**Re: The Compass School, SPEX 2008-0042
Response to Second Referral Comments**

SUBJECT: Response to Comments for Ashbrook - Compass School (Formerly Patriot Learning Center) Loudoun County Application Number: SPEX 2008-0042

**RE: The Compass School, SPEX 2008-0042
Response to First Referral Comments**

SUBJECT: Response Letter for VDOT Comments
Ashbrook – Compass School
Loudoun County Application Number: SPEX 2008-0042

Worst Case Scenario with 50% of site generated traffic approaching from the south along Navajo Drive

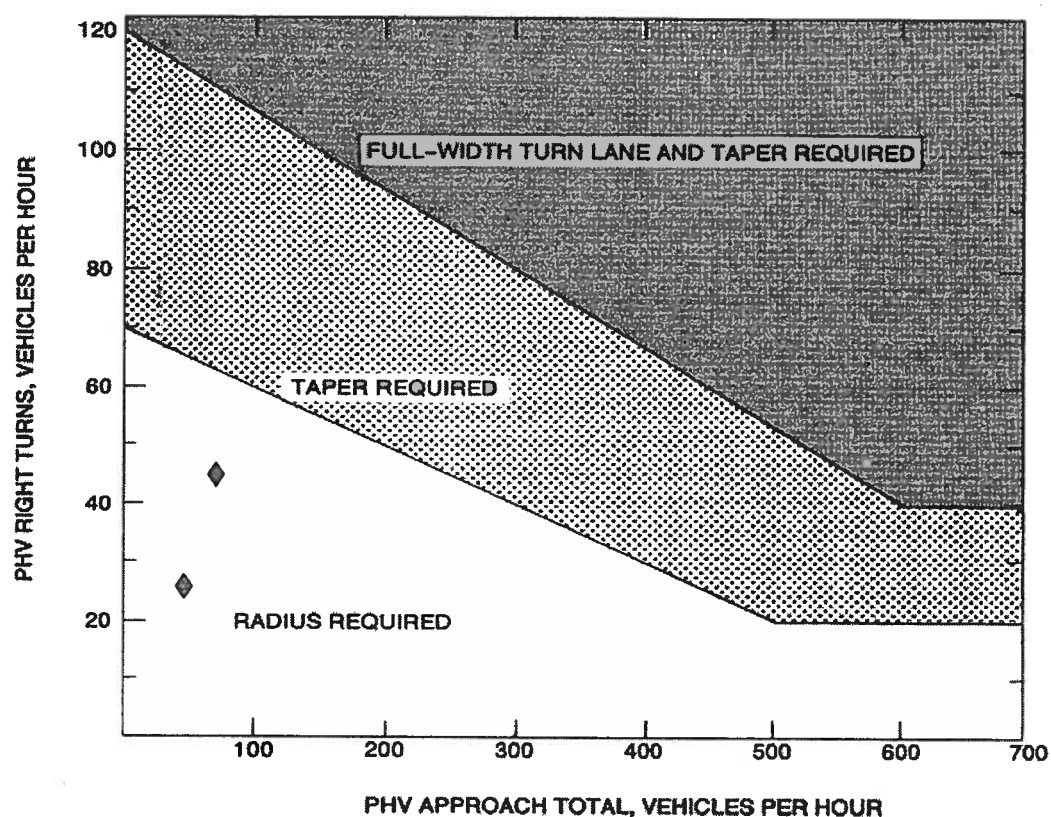
- 2) Our previous Comment 2 has not been satisfactorily addressed. Why is the AM peak hour volume so low? With this facility be not operating during this peak hour?*

- However, to be conservative, a revised analysis was conducted assuming 50% of the site-generated traffic approaching from the south along Navajo Drive and 50% from the north.

- The right turn lane, capacity and queuing analysis were revisited for this scenario.
- The results show that a right turn lane is still not warranted in the northbound direction at the site entrance even for the worst-case scenario. The intersection operates at acceptable levels of service and there are no queuing issues. The results of the queuing and capacity analysis are presented on the following pages. The Synchro worksheets are attached at the back of the memorandum.

- The revised future with development (2010) traffic volumes for this scenario are shown below:

Right Turn Lane Warrant Analysis (2-LANE)

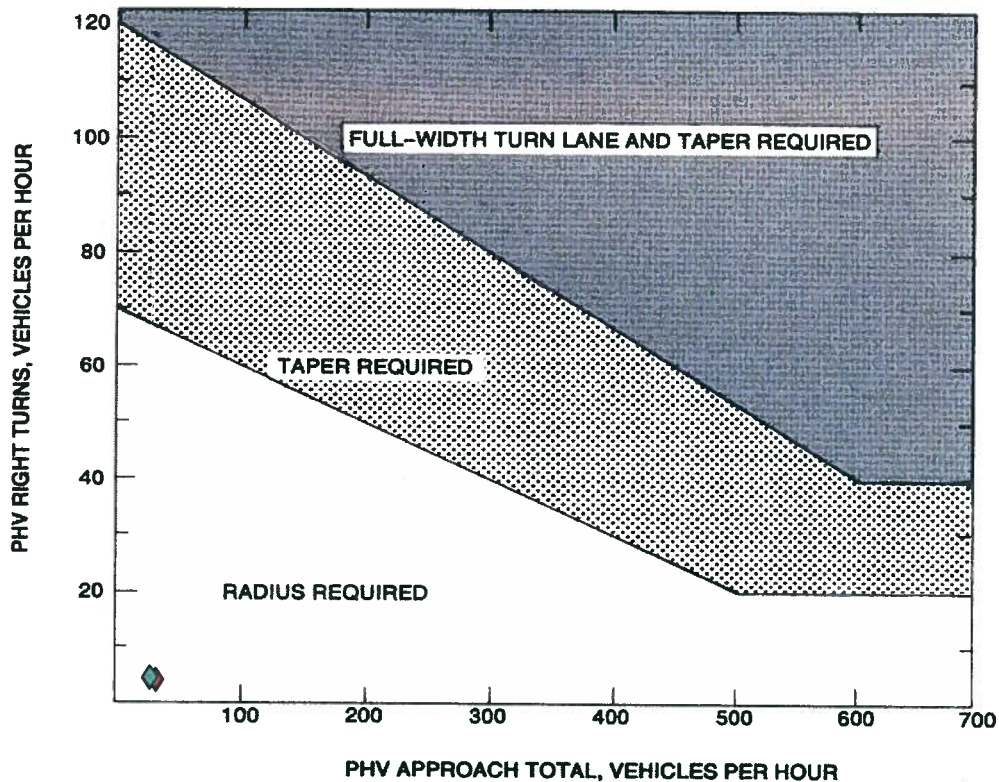
- 2) *The projected traffic volume (ADT) for existing Russell Branch Parkway and Navajo Drive should be shown on the plan. It appears that turning lanes (right and left) may be warranted at the proposed entrance.*

The projected traffic volume (ADT) for existing Russell Branch Parkway and Navajo Drive is shown on the plan. Left and right turn lane warrant analysis was performed at the proposed entrance for the future conditions. The analysis reveals that a left and right turn lane is not warranted at the school entrance. The detailed turn lane warrant worksheets are shown on the next page.

Right Turn Lane **Not Required**.
